Access Compliance Report

Public Rights-of-Way

Intersection ID: 11265	Main Street: N_TRYON_ST	Cross Street: WADSWORTH_PL	Location: E
ADA ID: 579717FD80DF	Ramp Type: Directional1	Initial Pass/Fail: Pass	Overall Compliance: No
		Severity Score: 5.25

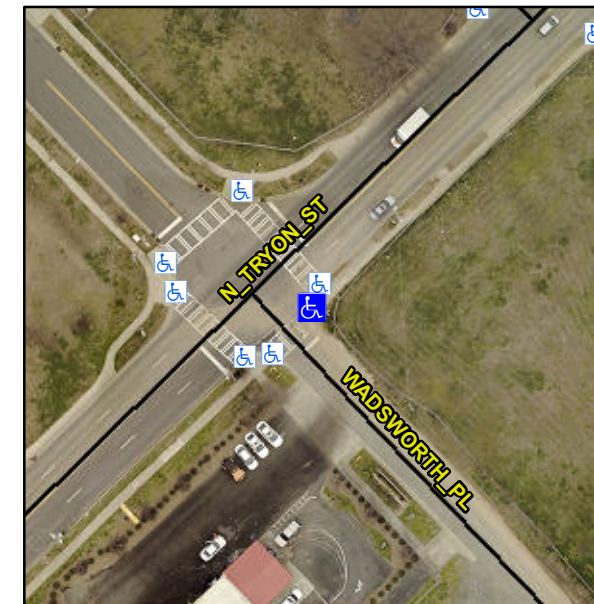
**Remove & Replace Entire Ramp.
Gutter Ponding Observed.**

R304.5.3, R304.2.3, R302.7

Possible Solutions:
